**UN Regulation No. 51 (Noise of M and N Categories of Vehicles)****Proposal for corrections to the 03 series of amendments to  
UN Regulation No. 51****Submitted by the experts from the International Organization of Motor  
Vehicle Manufacturers\***

This proposal concerns primarily amendments to Annex 7 of UN Regulation No. 51. The proposed changes are based on the 03 series of amendment to UN Regulation No. 51 up to Supplement 10. The modifications are marked in bold for new or strikethrough for deleted characters.

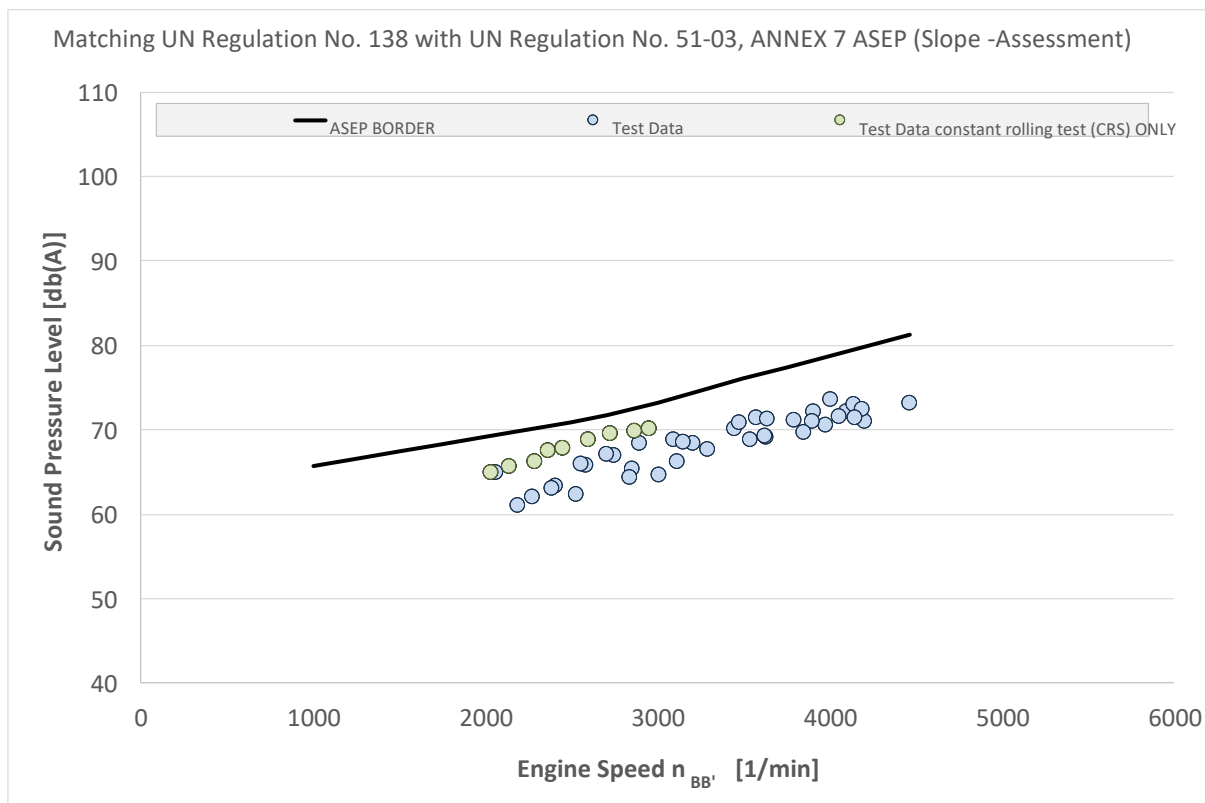
25. Electric vehicles can very often produce accelerations significantly higher than the acceleration achieved for the anchor point, which is limited to  $2 \text{ m/s}^2$ . Beyond  $2 \text{ m/s}^2$  the tyre torque effect can be dominant and may no longer fit to the fixed gear ratio of 20 km/h per 1000 rpm. Therefore, for accelerations higher than  $a_{wot, test}$  of Annex 3, a formula is proposed to introduce the performance based added sound – especially tyre torque, based on the Annex 9 term  $\Delta L_{va}$ .

26. The term accounts for the circumstance, that EVs can have very high acceleration independent of the gear, while ICE always need lower gears and higher engine speeds to provide high acceleration performance.

$$n_{BB,kj} = v_{BB,kj} / \left( 20 - 8 \times \log_{10} \left( \frac{a_{test}}{a_{anchor}} \right) \right) \times 1000$$

**for achieved accelerations  $a_{test} > a_{anchor}$ ; and**

$$n_{BB,kj} = v_{BB,kj} / 20 \times 1000$$

**for achieved accelerations  $a_{test} \leq a_{anchor}$**
